DRAINAGE INFORMATION SHEET

PROJECT TITLE: TANOAN AT HIGH DESERT ZONE ATLAS/DRNG. FILE #: E-22/014
DRB #: _____ EPC #: _____ WORK ORDER #: _____
LEGAL DESCRIPTION: TRACT N-1 TANOAN PROPERTY
CITY ADDRESS: CORNER OF ACADEMY BLVD. AND TRAMWAY BLVD.
ENGINEERING FIRM: WILSON AND COMPANY CONTACT: DAVID B. THOMPSON
ADDRESS: 6611 GULTON CT. NE PHONE: (505) 345-5345
OWNER: SNK CONTACT: ED J. MYSLIVY
ADDRESS: 5907 ECKERT #805 PHONE: (210) 699-3901
SAN ANTONIO, TX 78201-99 CONTACT: RANDY HARRIS
ARCHITECT: HDO ARCHITECT-PLANNERS PHONE: (510) 934-4206
ADDRESS: 2950 CAMINO DIABLO SUITE 105
WALNUT CREEK, CA 94596 CONTACT: _____
SURVEYOR: _____ PHONE: _____
ADDRESS: _____ CONTACT: _____
CONTRACTOR: _____ PHONE: _____
ADDRESS: _____

RE: GRADING PERMIT APPROVAL FOR TRACT N-1 TANOAN (E-22/D16) ENGINEER'S STAMP
DATED 8/17/94

TRACT N-1
TANOAN PROPERTIES
CONCEPTUAL DRAINAGE MANAGEMENT
PLAN

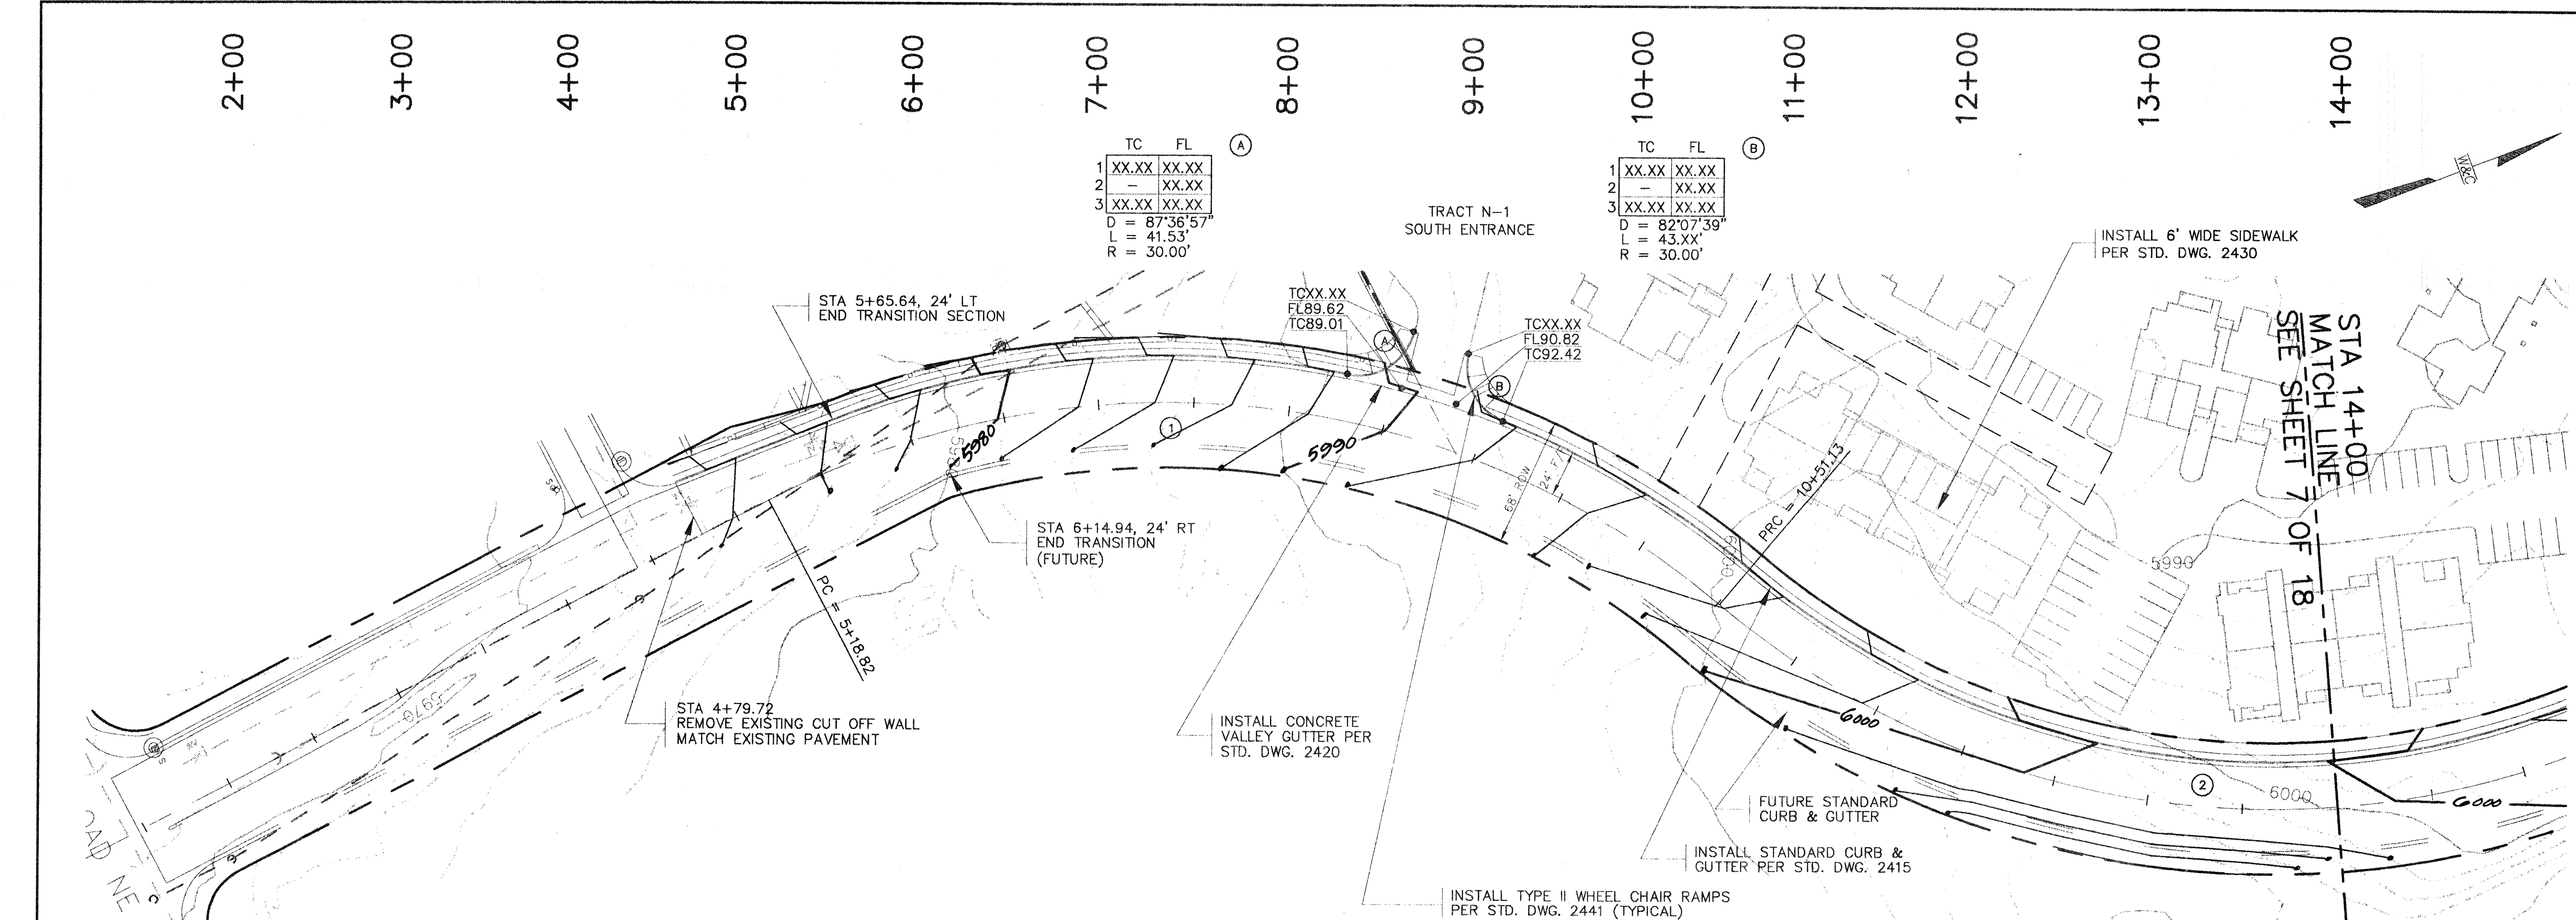
Not clear to where the erosion setback line is at, please show on drawing 1"=100' also show official 100 year floodplain.

comment to keep development above the spillway elevation.

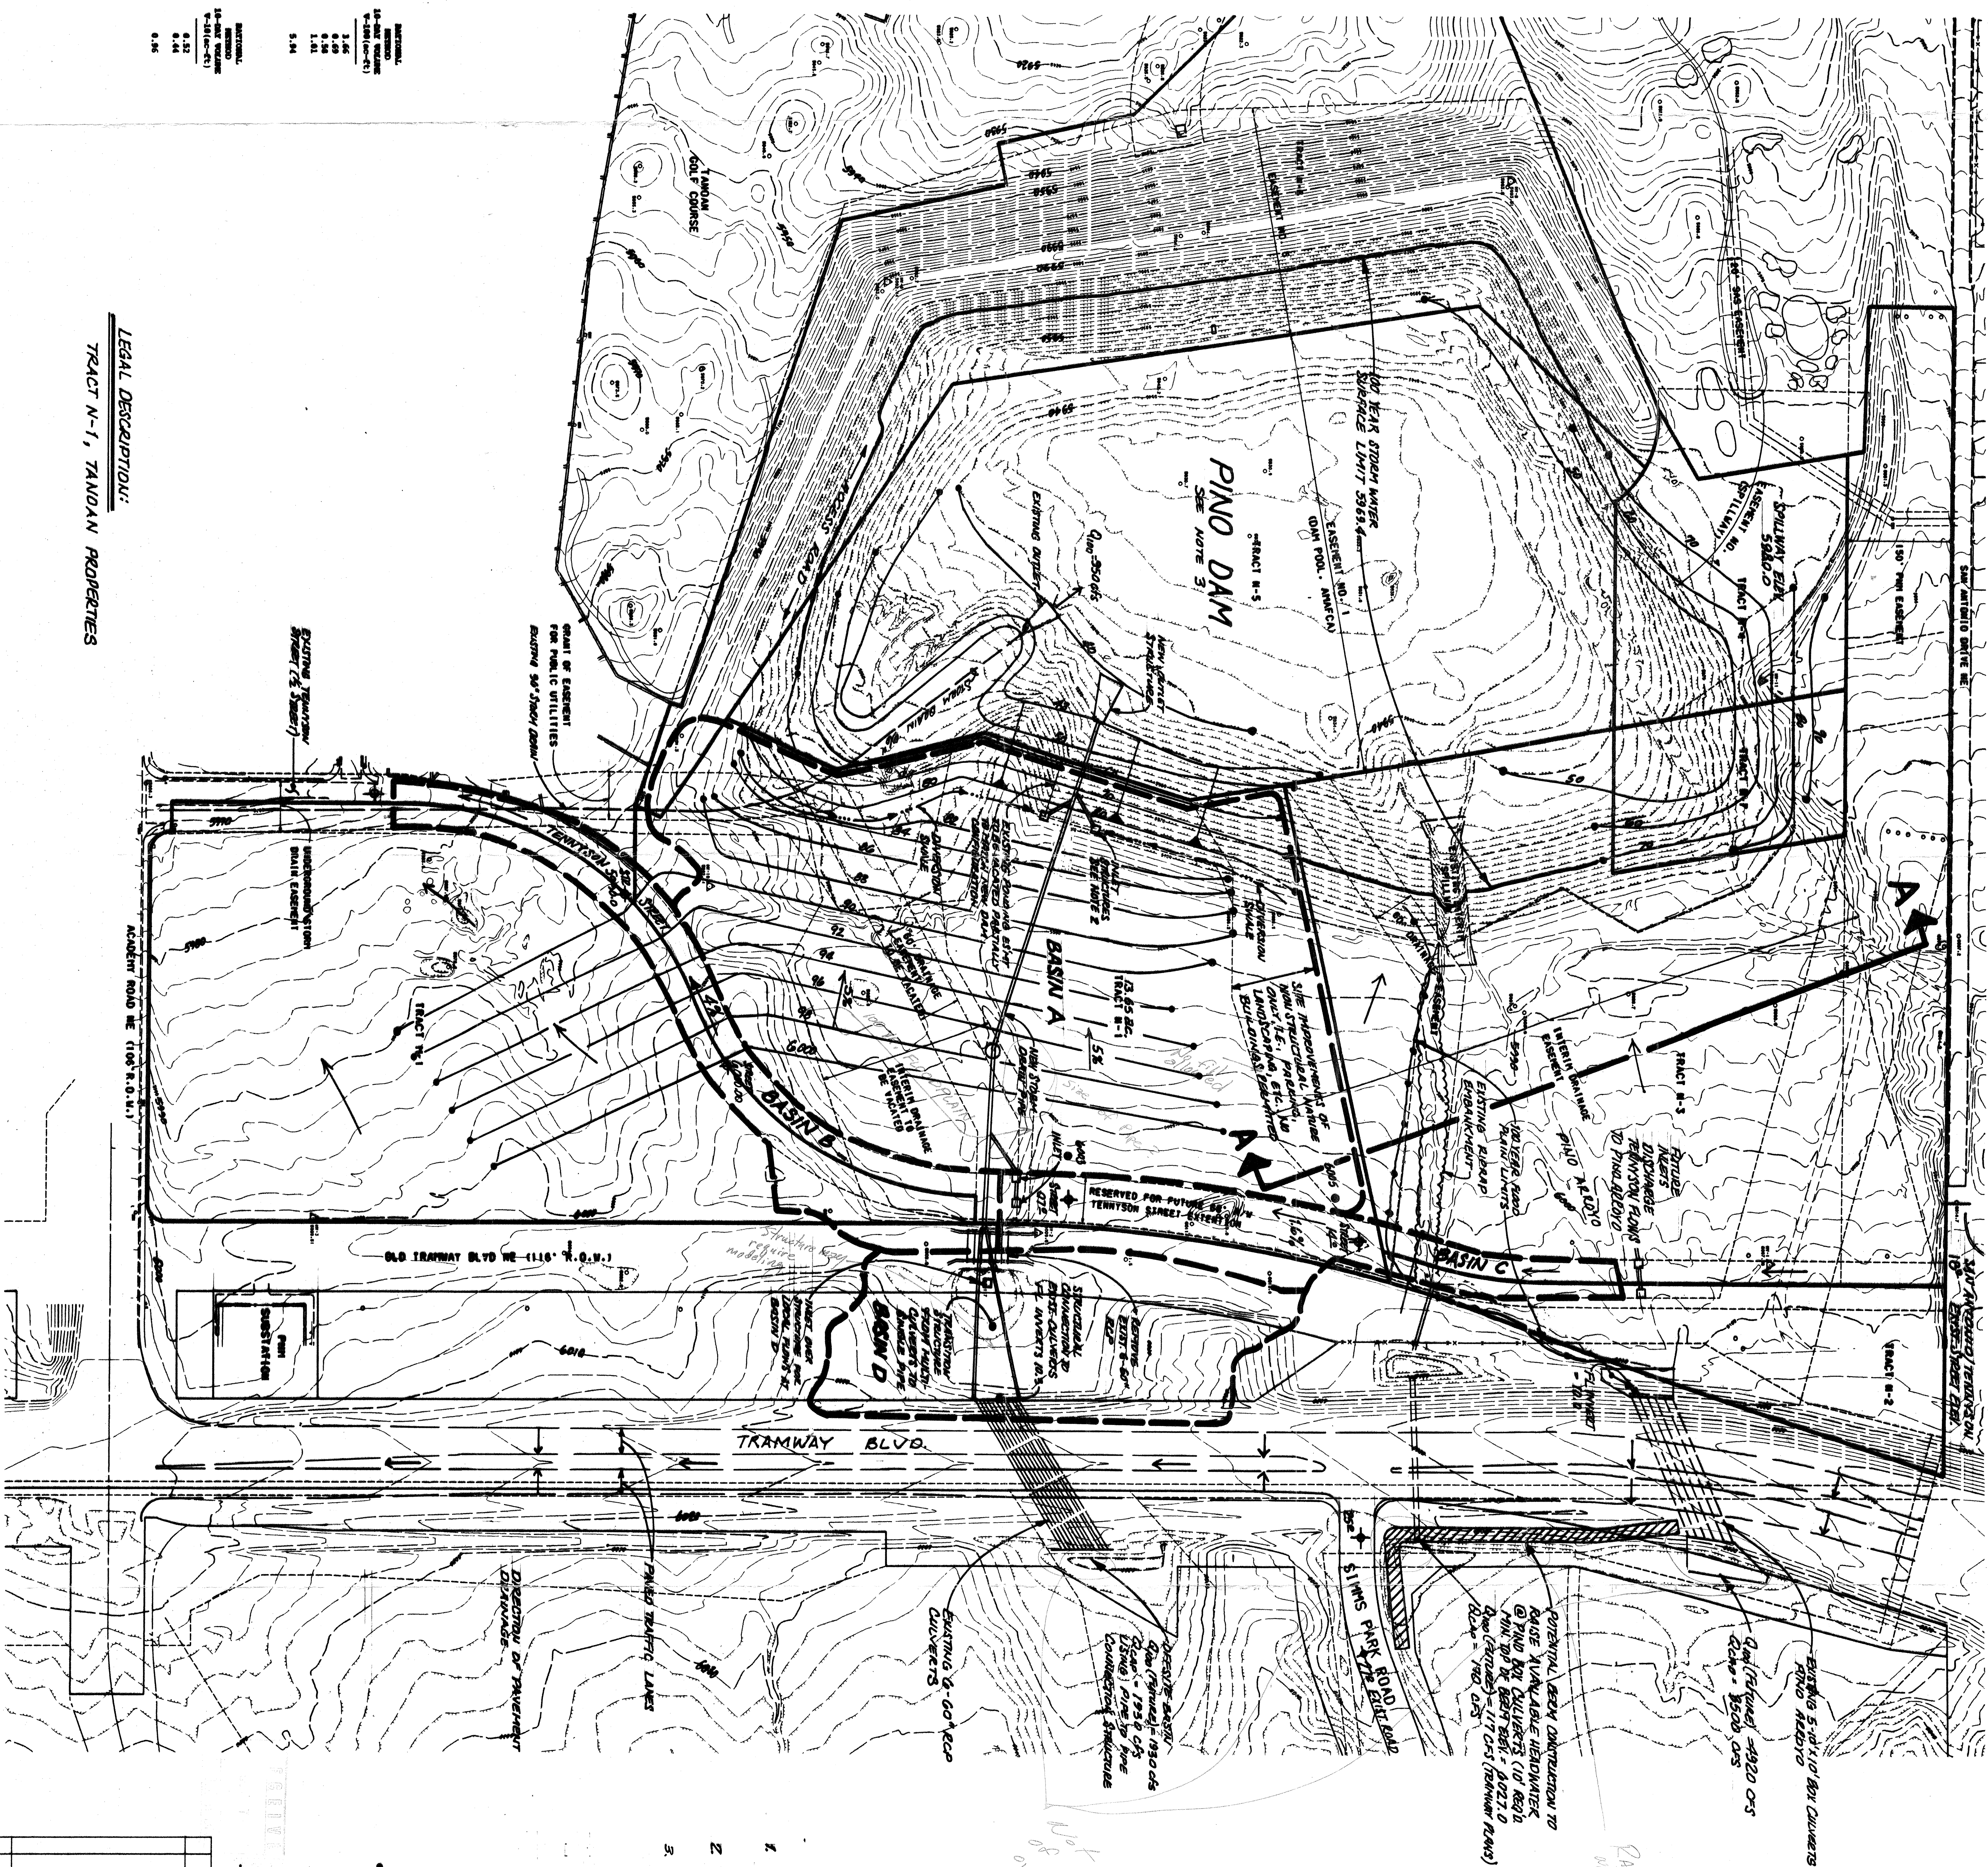
Not clear on amount of dead water available over culverts, that 3 feet of F&B board minimum is required L&M approve.
